Addendum # 7

Dated: October 04, 2024

Bid Opportunity: T-24-33 - General Contractor for the Construction of a Helicopter Hangar and Related Interior and Exterior Spaces in the Town of East Gwillimbury, Ontario

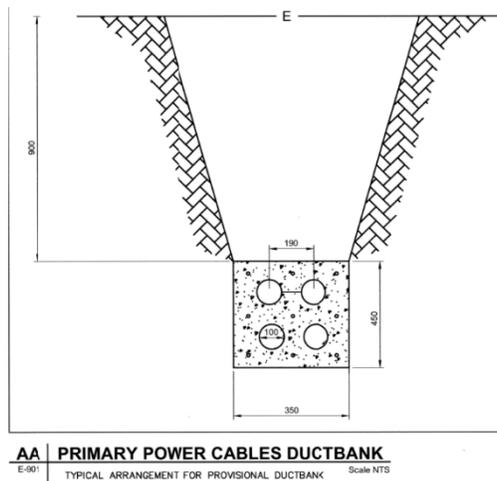
In the Elect. drawing of Addendum#4, it is mentioned references of Dwg. E-901 for various duct banks. But in E-901, there are no such drawings. It refers only electrical Schedules.

Answer 200: The pdf drawings provided were for reference and coordination. The duct banks are existing and not part of this project unless specifically noted. Refer to Addendum 6, Detail 2/E-100 and note that Hangar project will make use of the existing duct bank under the existing road. (2x2x 103mmC).
